**ADDENDUM NO. 2**

**June 3, 2025**

**Taxiway A Reconstruction – Phase 6 and Midfield Ramp Repair – Phase 3**

**Duluth International Airport  
Duluth Airport Authority  
AIP No. 3-27-0024-080-2024  
SP No. A6901-220, A6901-222  
City of Duluth No. 25-4406  
SEH No. DULAI 179719 & 180793**

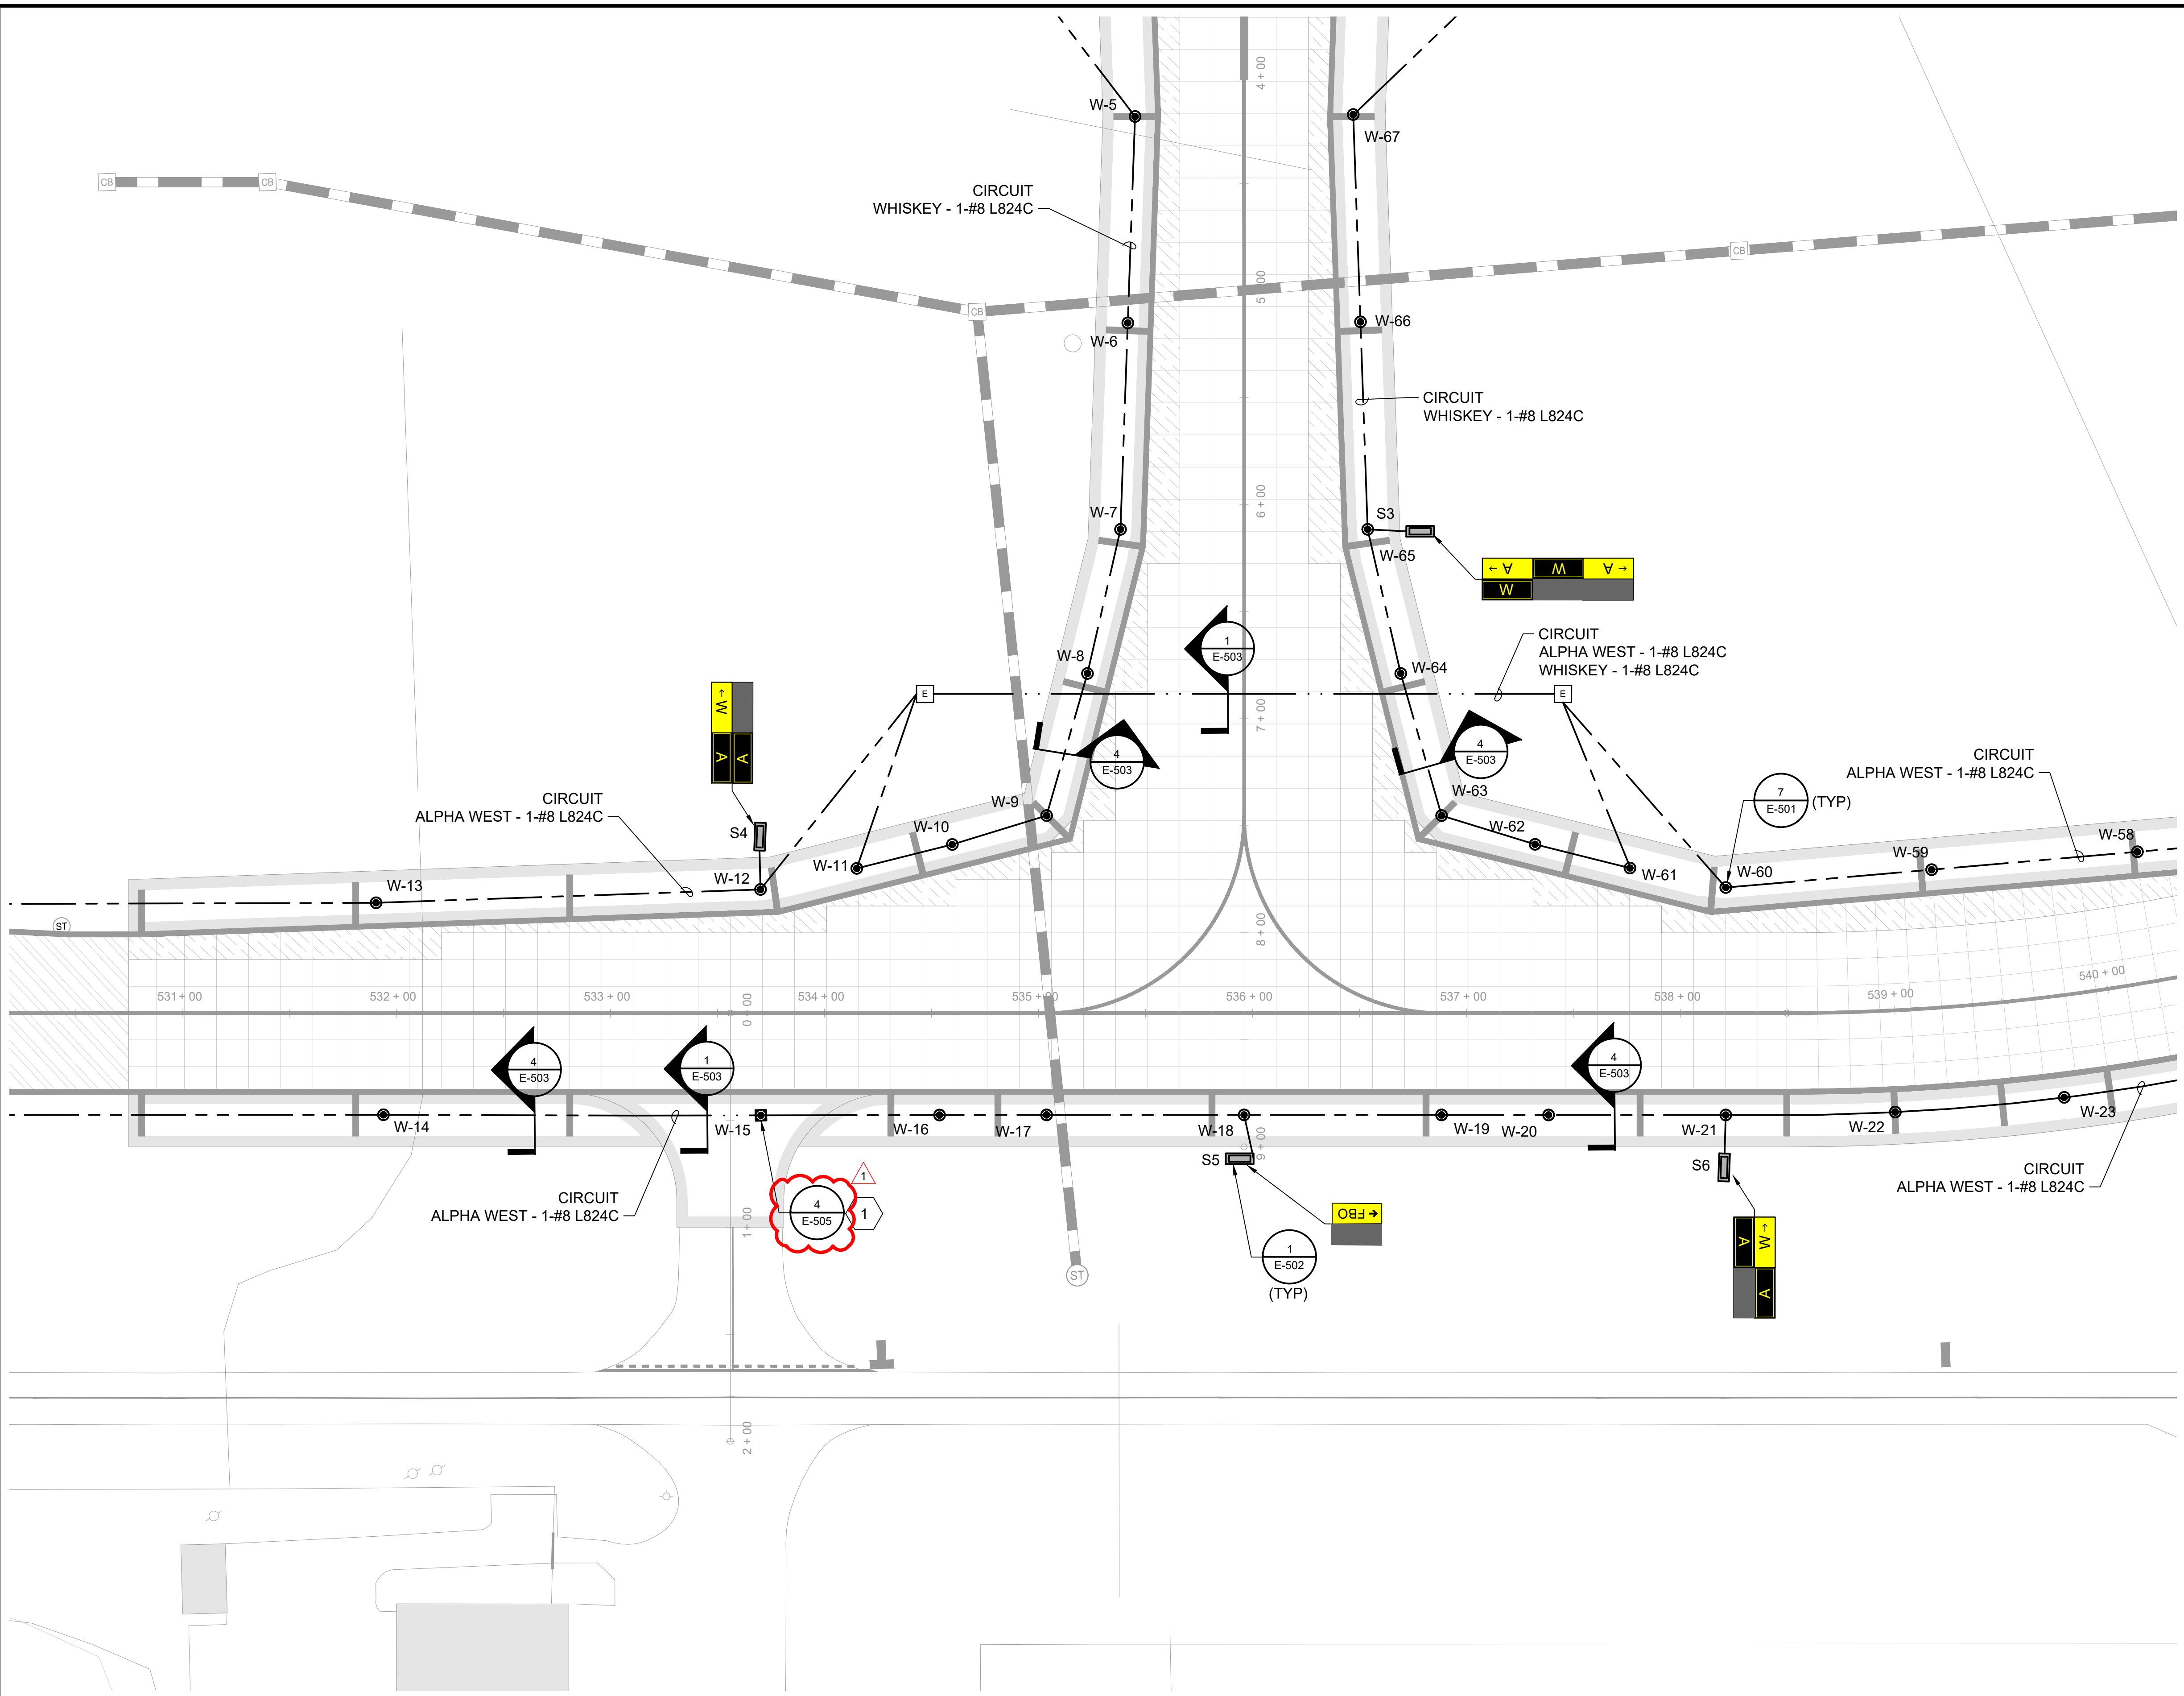
3. Plan Set A – Drawing E-104 Electrical New Work Plan – Area 4: Updated detail callout for a taxiway edge light. DELETE in its entirety and REPLACE with the attached revised drawing.

- KEYED NOTES:**
- 1 PROVIDE NEW L-852T(L) SEMIFLUSH TAXIWAY EDGLIGHT ON L868B BASECAN.

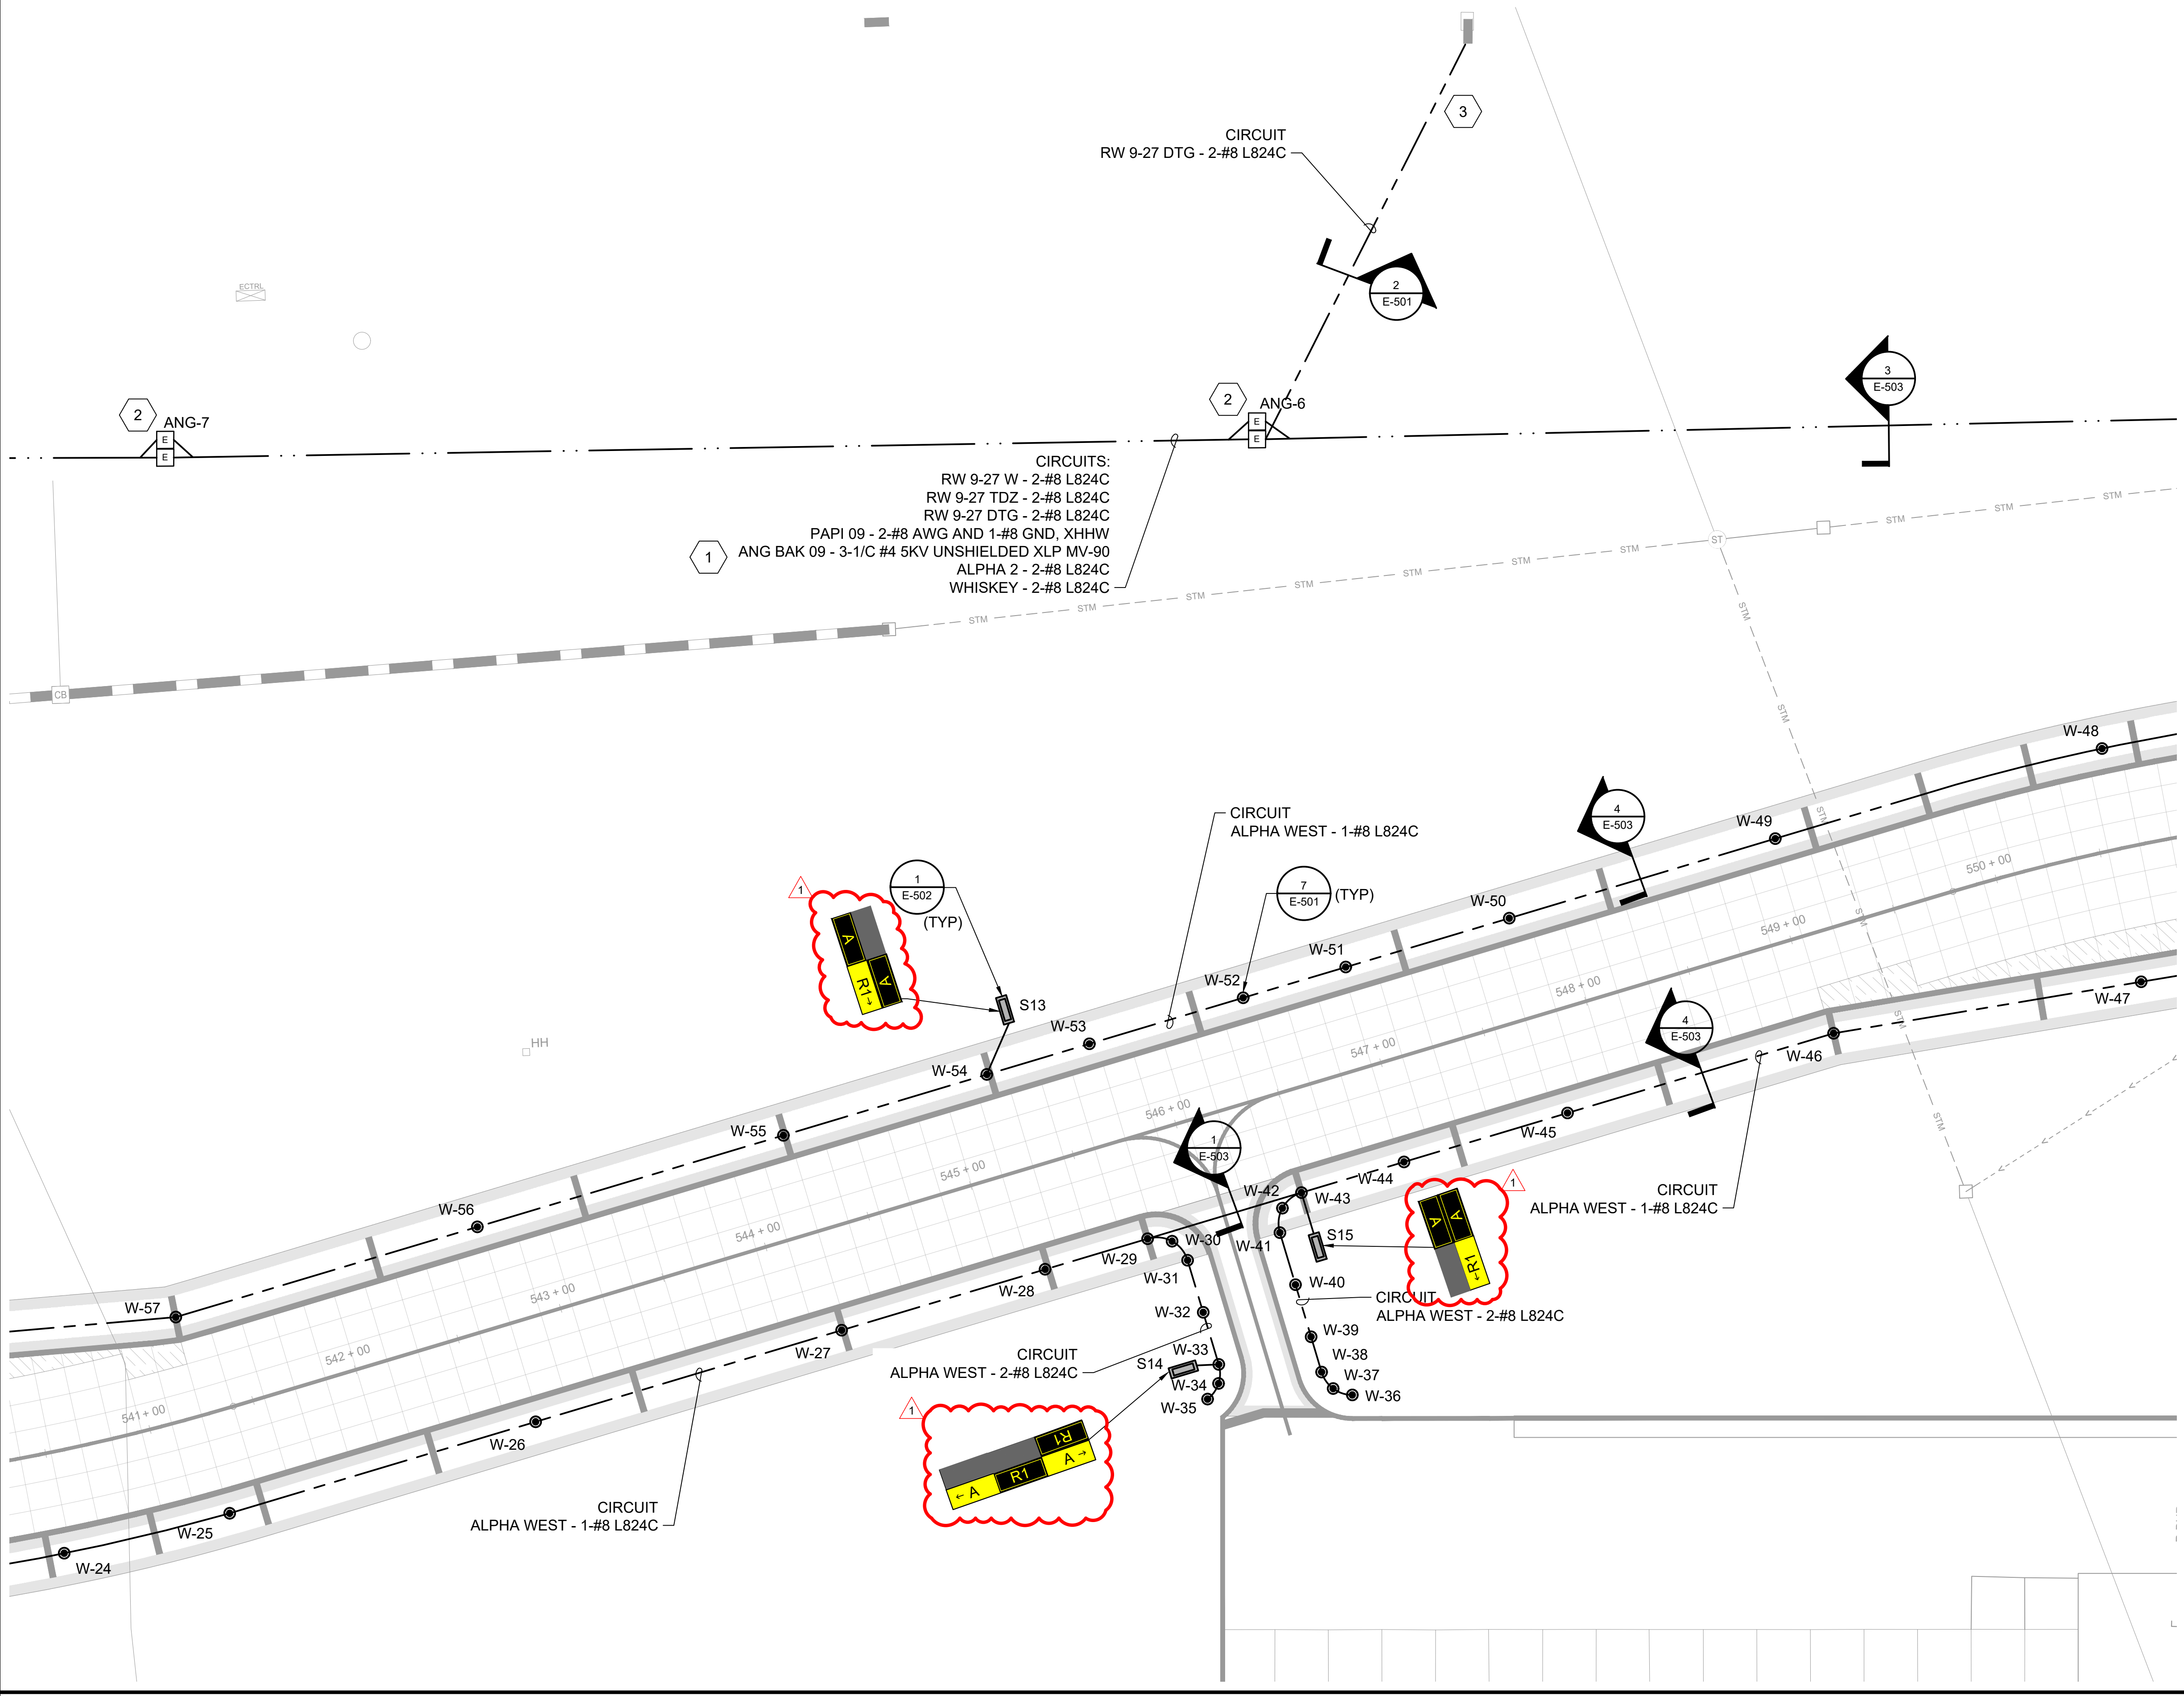
4. Plan Set A – Drawing E-105 Electrical New Work Plan – Area 5: Updated panel designations and orientations for three airfield electrical signs (sign S13, S14, S15). DELETE in its entirety and REPLACE with the attached revised drawing.

**AIRFIELD SIGN SCHEDULE**

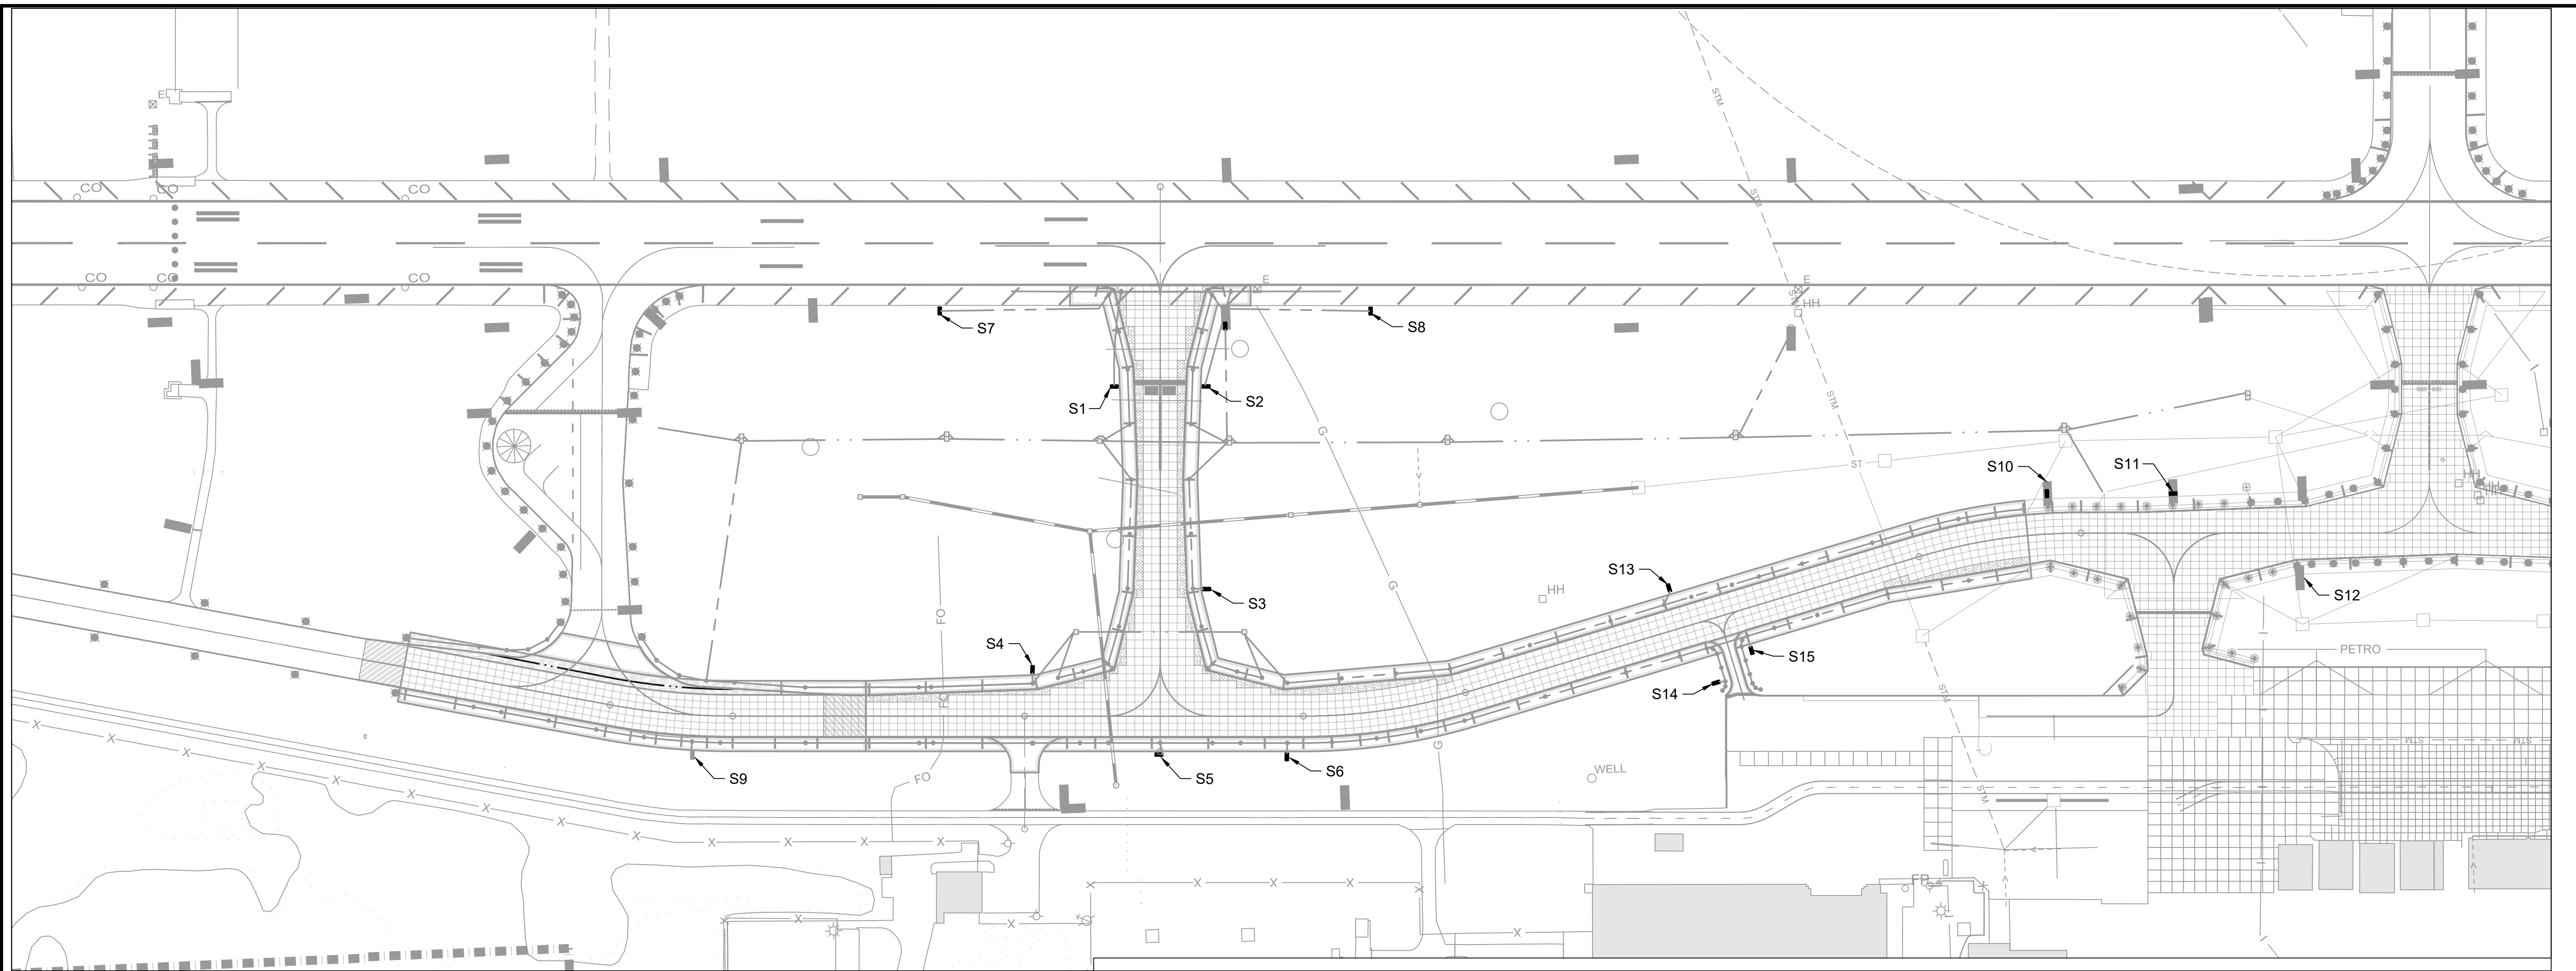
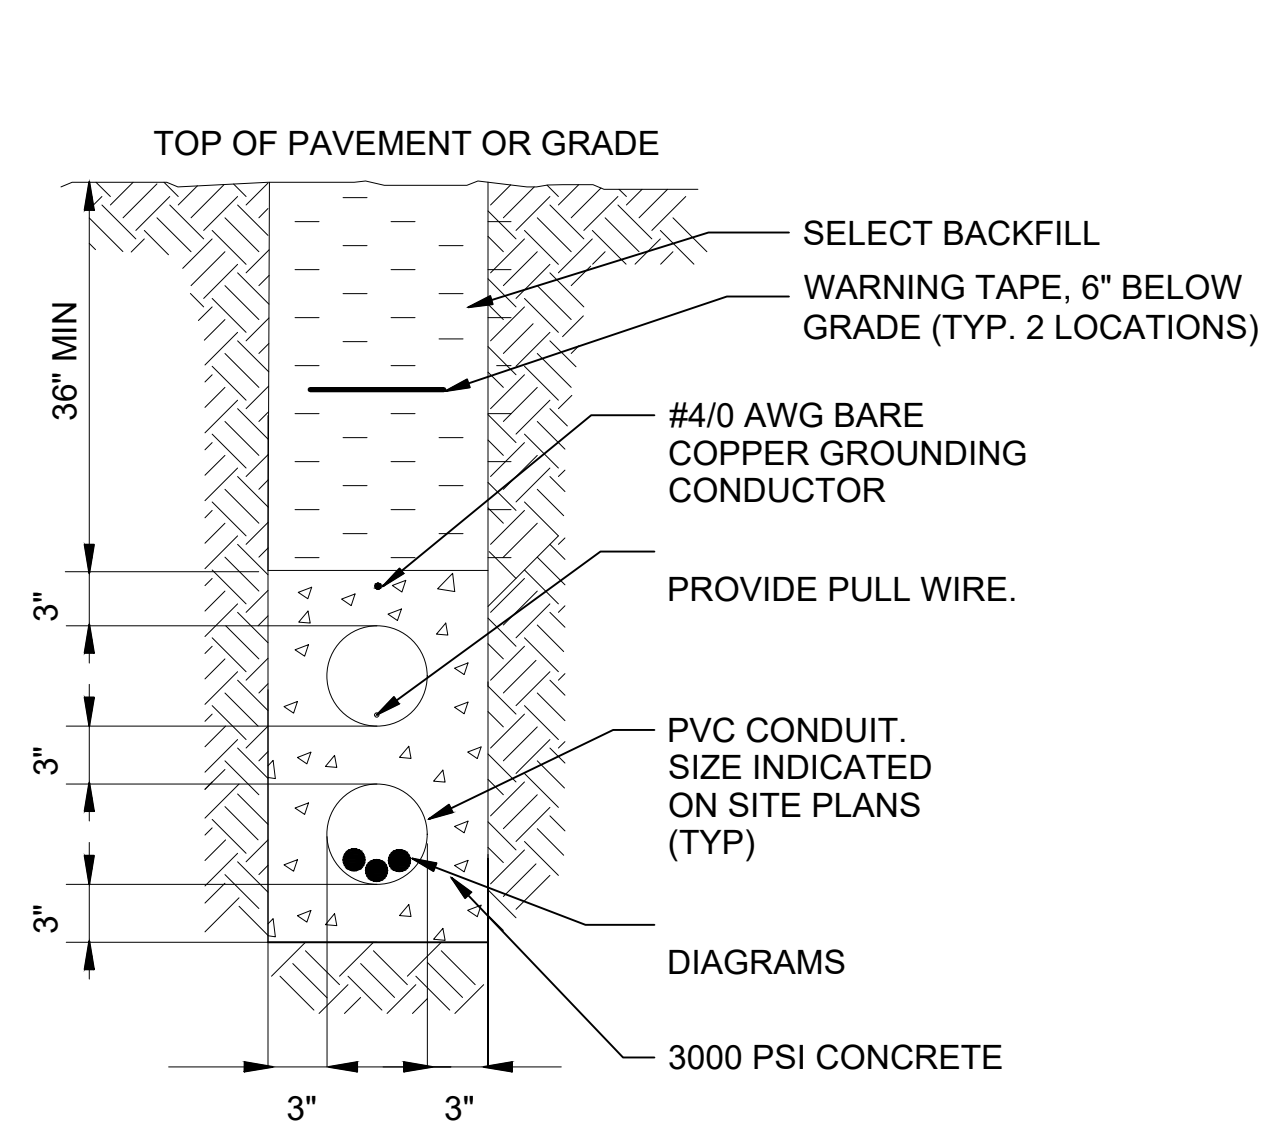
5. Plan Set A – Drawing E-111 Electrical Signage Legend: Updated table to reflect panel designation changes for three airfield electrical signs (sign S13, S14, S15). DELETE in its entirety and REPLACE with the attached revised drawing.
